# **SERIES 100 FLASH MEMORY MINIATURE CARD SPECIFICATION UPDATE**

Release Date: February 1997

Order Number 297717-003

The iFM002A and iFM004A may contain design defects or errors known as errata. Characterized errata that may cause the iFM002A and iFM004A's (Series 100 Miniature Cards) behavior to deviate from published specifications are documented in this specification update.

## IDENTIFICATION INFORMATION

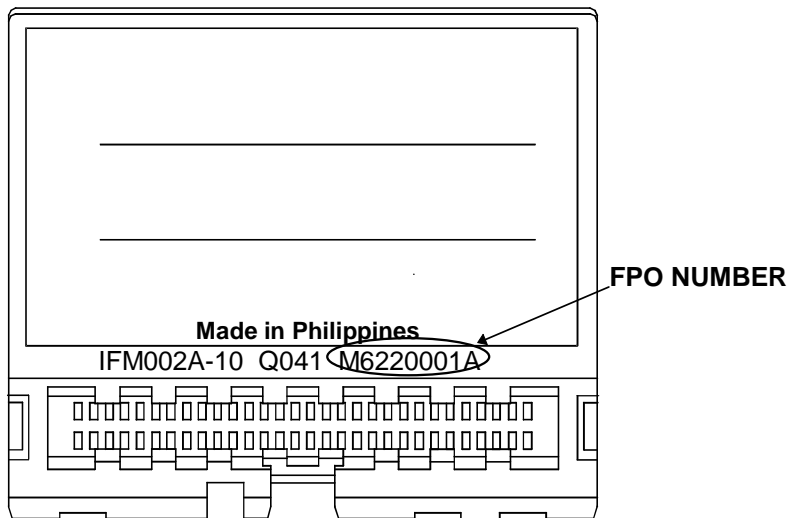
The Finished Processing Order (FPO) number correlates to a specific device stepping as illustrated in the table below:

Stepping <sup>(1)</sup>	Identifier
A through H Stepping	Last digit of the FPO number is A through H respectively.

An FPO number contains the following information that describes the origin of the card:

The first character denotes the assembly site where "M" = Manila. The next character is the last digit of the year in which the unit was manufactured. In the above example, the unit was built in 1996. The next two digits are the week in the year. The remaining four digits are the lot number, and the last letter is the stepping. The above example shows a unit that was from lot 0001, built in Manila during week 22 of 1996. The last digit denotes that it is an A-step unit.

**CE# Glitch**

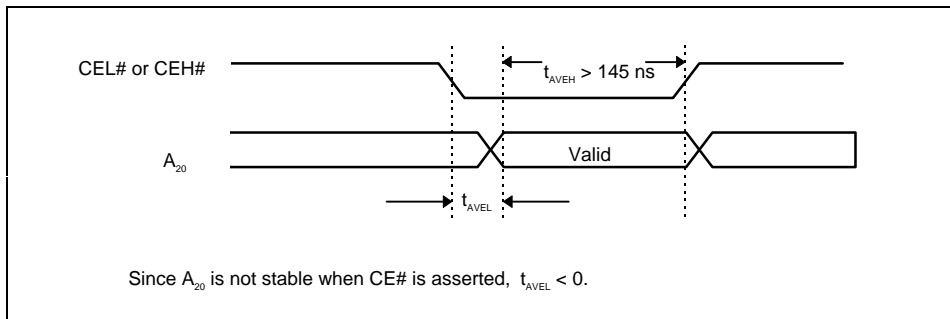
1. Either or both CE# inputs is asserted for less than 60 ns. This is depicted in *CE# Glitch* illustration, below.
2. On a 4-Mbyte card, the A<sub>20</sub> input is not stable prior to the assertion of either or both CE# inputs (the A<sub>20</sub> input is not connected on the 2-Mbyte card). Refer to Figure *A<sub>20</sub> Lags CE#*, below.

If either of these sequences of control inputs are repetitiously applied, incorrect data can be returned in subsequent reads.

**WORKAROUND:** If it is suspected that the Miniature Card socket controller is causing glitches, there are three ways that the card can be returned to the state where it is reliably reading data.

1. Perform a single word write operation, even one where the data written is all ones. A word write operation consists of a setup command—40h to recover from CEL#, 4000h for CEH# or 4040 for CEL# and CEH—followed by the data. If the data written is all ones, then the contents of the card will not be changed. Any zeros written to the array will be written correctly.
2. Put the card in standby mode, deassert CE#, for more than 50 ms.
3. Assert CEL# or CEH#, drive them low, for at least 13  $\mu$ s.

**A<sub>20</sub> Lags CE#**

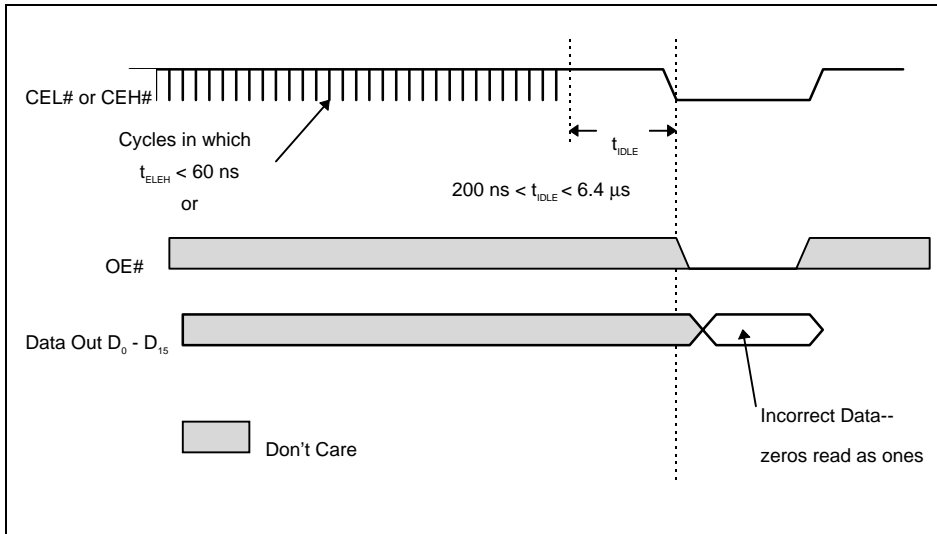
A single application of the above sequences does not cause an errant read. The problem has only been observed after several hundred of either of the above sequences, and even then it is very intermittent.

Finally, this problem was observed very infrequently on a few systems when using 4-Mbyte cards. In those systems, the controller applied A<sub>20</sub> about 30 ns after CE# was asserted. This caused one chip-pair to experience a glitch just prior to the second chip-pair being read.
